CURRENT THERMOSTAT

OLD THERMOSTAT

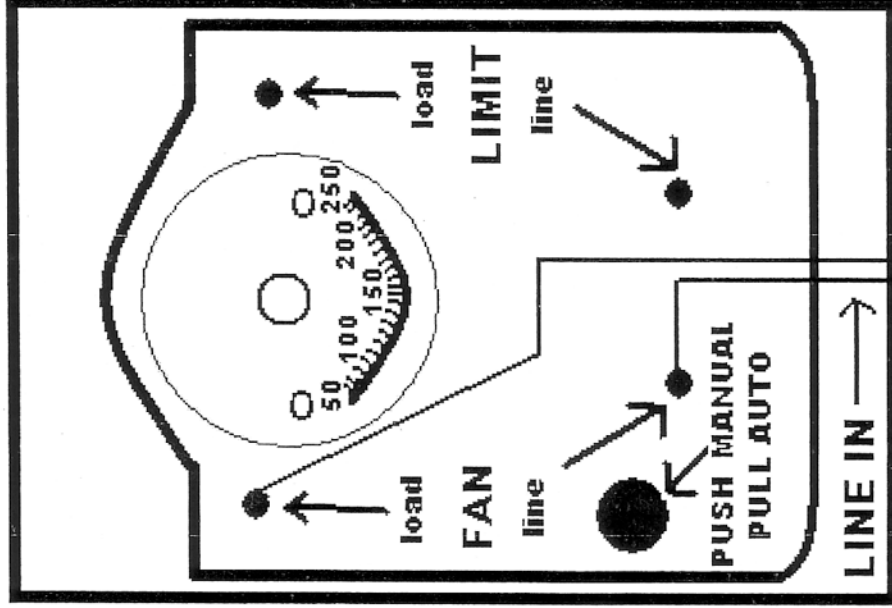
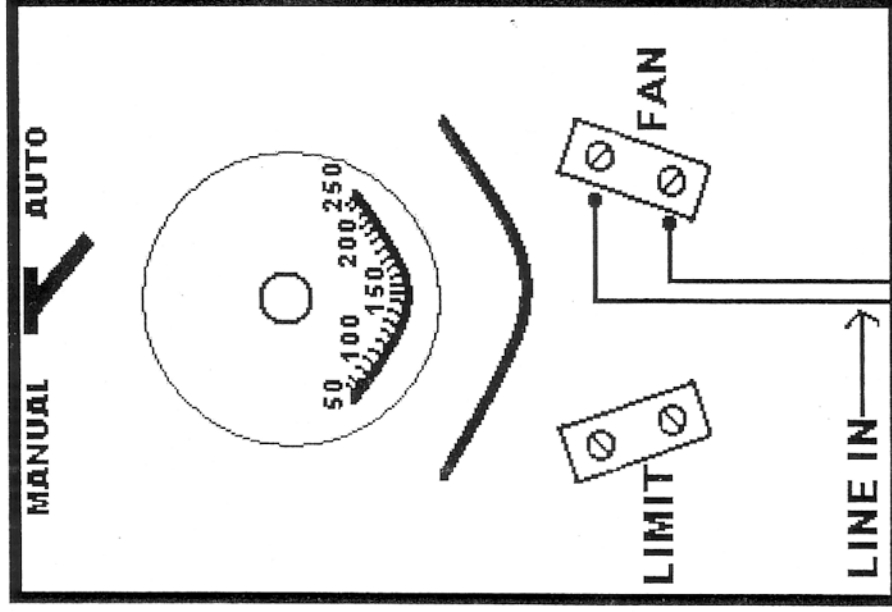
NOTE: TO CHANGE OVER TO THE PUSH BUTTON STYLE THERMOSTAT CUT THE EYELETS OFF AS CLOSE TO THE CONNECTOR AS POSSIBLE LEAVING AS MUCH WIRE AS YOU CAN. THEN STRIP THE WIRE JACKET BACK 1/4". NEXT INSERT THE WIRES INTO THE QUICK CONNECTS ON YOUR NEW THERMOSTAT.
